Thursday, 5/22/2008 12:06:55 PM -Date: User: Chantal Lavoie **Process Sheet Drawing Name: FOOT** Customer: CU-DAR001 Dart Helicopters Services Part Number: D37871 Job Number: 39397 Job Number: Description: Seq. #: Machine Or Operation: INSPECT WORK TO CURRENT STEP 6.0 QC5 08.05.23 Comment: INSPECT WORK TO CURRENT STEP PACKAGING RESOURCE #1 **PACKAGING** 7.0 Comment: PACKAGING RESOURCE #1
Identify and Stock FOR ENGINEERING USE OHLY PH 08.05.28 Location: FINAL INSPECTION/W/O RELEASE QC21 8.0 Comment: FINAL INSPECTION/W/O RELEASE Job Completion DATE

PROTOTYPE PLEASE RETURN ALL ISSUED DATA TO ENGINEERING 08.05.06 Ø0,853 (REF) Ø0.323 (B) 0.378 и ш MS22034-1B ADAPTER, QUICK DISCONNECT, PASSENGER SEAT TO FLOOR D3787-1 FOOT REV. DESCRIPTION DATE NOTES:
1) MATERIAL: N/A
2) FINISH: CHEMICAL CONVERSION COAT PER DART QSI 005 4.1
3) TOLERANCES: PER DART QSI 018 UNLESS OTHERWISE NOTED
4) UNITS: INCHES UNLESS OTHERWISE NOTED
5) BREAK SHARP EDGES: 0.005 TO 0.010 MAX
6) IDENTIFICATION. N/A
7) WEIGHT: 0.13 lbs
8) DRILL \$\(\phi\)0.323 HOLE 0.378" FROM SHOULDER DESIGN DART AEROSPACE LTD HAWKESBURY, ONTARIO, CANADA HS DRAWN HS DRAWING NO. CHECKED REV. A D3787 MFG. APPR. SHEET 1 OF 1 APPROVED TITLE SC

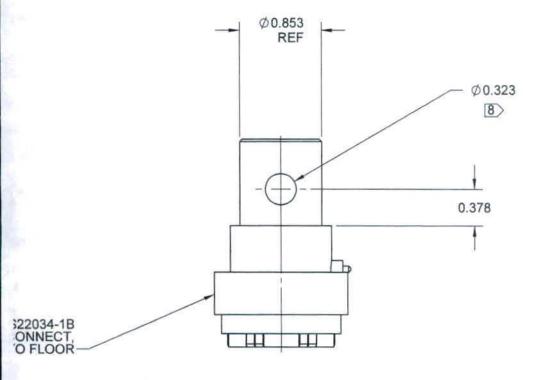
On the drawing, it is not clear as to weather the hole 0.323 is a through hole. I appears to me going by the assembly, that it should be, but the question was asked on the floor. Please add a note to the drawing for future clarification. And can I get a response on this to inform the employees?

I believe that the drawing meets the requirements of QSI043 6.3.10.1.1 – which indicates that a through hole is dimensioned with a diameter and that's it. However I will try to twist the iso view in the corner so that the user can see the other half of the hole.

In short - YES it is a thru hole.
